DETAILED ACTION

Figure i- The APA provided by applicant.

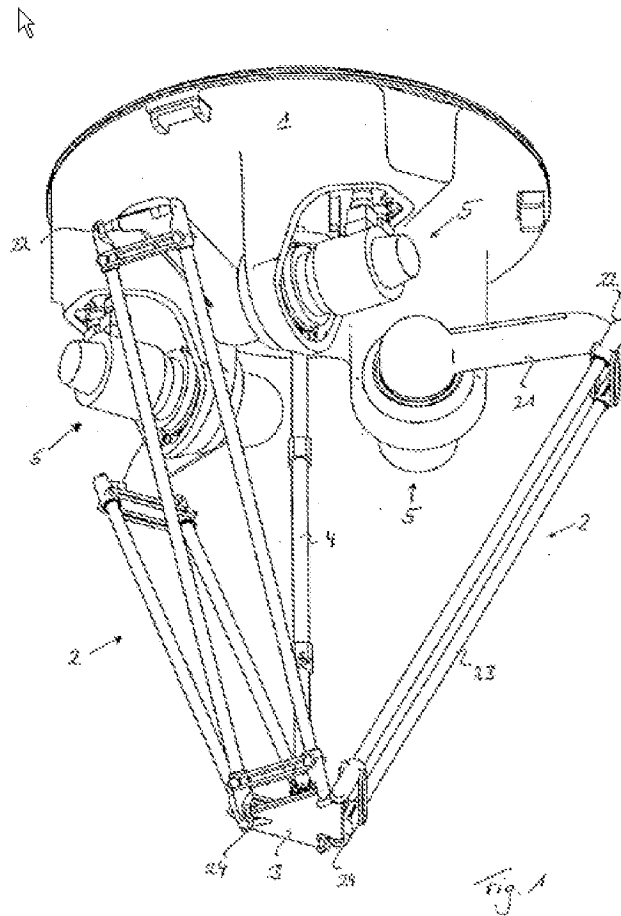
1. Figure 1 should be designated by a legend such as --Prior Art-- because only that which is old is illustrated. See MPEP § 608.02(g). Corrected drawings in compliance with 37 CFR 1.121(d) are required in reply to the Office action to avoid abandonment of the application. The replacement sheet(s) should be labeled "Replacement Sheet" in the page header (as per 37 CFR 1.84(c)) so as not to obstruct any portion of the drawing figures. If the changes are not accepted by the examiner, the applicant will be notified and informed of any required corrective action in the next Office action. The objection to the drawings will not be held in abeyance.
2. The drawings are objected to under 37 CFR 1.83(a). The drawings must show every feature of the invention specified in the claims.

- a base element corresponding to a base element(fig.1, 1) in the APA.
- At least three motor/gearing units disposed on the base element corresponding to the motor/gearing units (fig.1, 5) of the APA.
- A common supporting element on which at least one gripping means for gripping an object is disposed. The supporting

element corresponds to the supporting element (fig.1, 3) of the APA, and the applicant recites a 112th 6th paragraph limitation in regards to the gripping means which is disclosed on page 2, paragraph 24 in the discussion of the APA.

- At least three arms corresponding to arms (fig.1, 2) of the APA. One end is connected to the motor unit and a second end hinge-connected to the common supporting element which is also taught by the APA, fig.1.
- The motor/gearing unit having a gearing with at least one gear step which is tensioned. The APA fails to disclose this.
- The gear step, having a material-locking or positive-locking connection between gearing components, and being free or virtually free from backlash over the whole motional range of the gearing. The APA fails to disclose this as well.

Applicant claims the device with precisely three arms, precisely three motor/gearing units and where the units are positioned on one side each of an imaginary triangle. The APA teaches all this structure in figure 1 along with the proper positioning.

Applicant claims the device where the imaginary triangle is an equilateral. The APA also teaches this as seen in figure 1.

Applicant claims the device comprising a telescopic forth shaft connected to the carrier element. The APA teaches a telescopic forth shaft (fig.1,4) connected to a carrier element (fig.1, 3).

Figure ii- Mochizuki et al.'s figure.

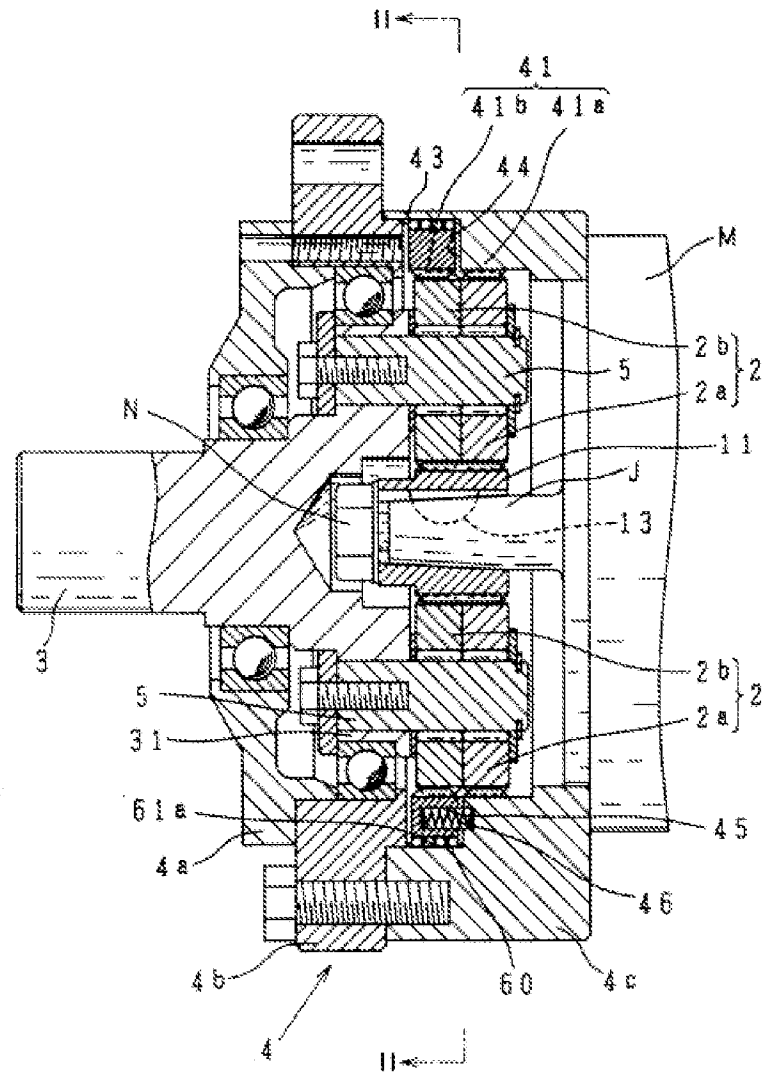
Mochizuki et al. teaches a gearing unit with a gear step which is tensioned via springs (fig. 11, 46). This controls the positioning of the internal gear (col.8, lines 51-59). The gear step has a material-locking connection as seen in figure 11 since the gears are interlocked together. Additionally, the gearing unit is free of backlash as discussed in the abstract and col.9, lines 1-5.

Mochizuki et al. teaches a gear step seen in figure 10 and 11 where the rotation axes of the gears on the drive side and power take off side run coaxially and offset to each other, and Mochizuki et al. teaches a motor M (fig.10, M) coaxially connected to the gear step for the purpose of driving the gearing.

Applicant claims the gearing of the device being a planetary gearing which has planet wheels which mesh between a sun wheel and a ring wheel and which are respectively fixed by a planet wheel bolt to a planet carrier and are mounted rotatably about the respective planet wheel bolt. Mochizuki et al. teaches a planetary gearing unit (fig. 10, 4) which has planet wheels (fig.10, 2), which mesh between sun wheel (fig.10, 11) and internal gear or ring wheel (fig.11, 41b) and the planet wheels are mounted rotatably about the respective bolt seen in figure 10.

Applicant claims the gearing of the device being a planetary gearing, where the gearing has planet wheels which mesh between a sun wheel and ring wheel, with the axes of the planet wheels being arranged offset in comparison to the axis of the sun wheel. Mochizuki et al. teaches all these components as discussed in claims 19-20 and also teaches the axes of the planet wheels being offset with the sun wheel as can be seen in figures 10 and 11.

Applicant claims the gearing of the device as being of single-step or multiple-step configuration. Mochizuki et al. teaches a planetary gearing unit having a multiple-step configuration as can be seen in figure 11. There are multiple step reductions possible using this gear set up.

Applicant claims the device wherein the at least one tensioned gear step is tensioned in a rotationally symmetric manner. Mochizuki et al. teaches this via figure 10 and 11 and col.10 lines 45-47, where as seen the springs are located symmetrically about the gearing unit and therefore tension the gear step in a rotationally symmetric manner.

Figure iv- Altenbokum et al. figure.

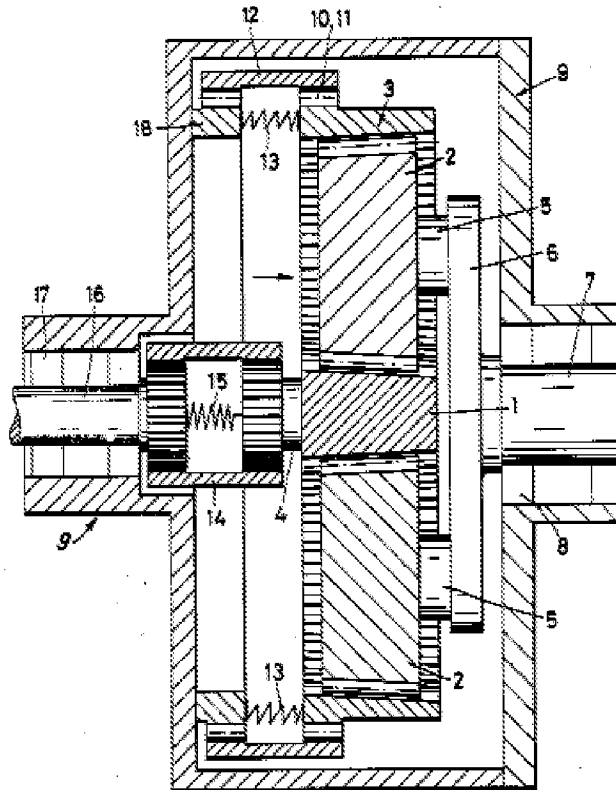
Altenbokum et al. discloses a planetary gearing that has a spur gear combined inside (fig.1, 3) and (col.2, line 16 and line 31). This planetary gear also has a gear step seen in figure 1 wherein the drive side axis running through element 1, is offset to the power take off side axis running through element 5. This planetary gear unit provides a play-free or backlash free planetary drive.
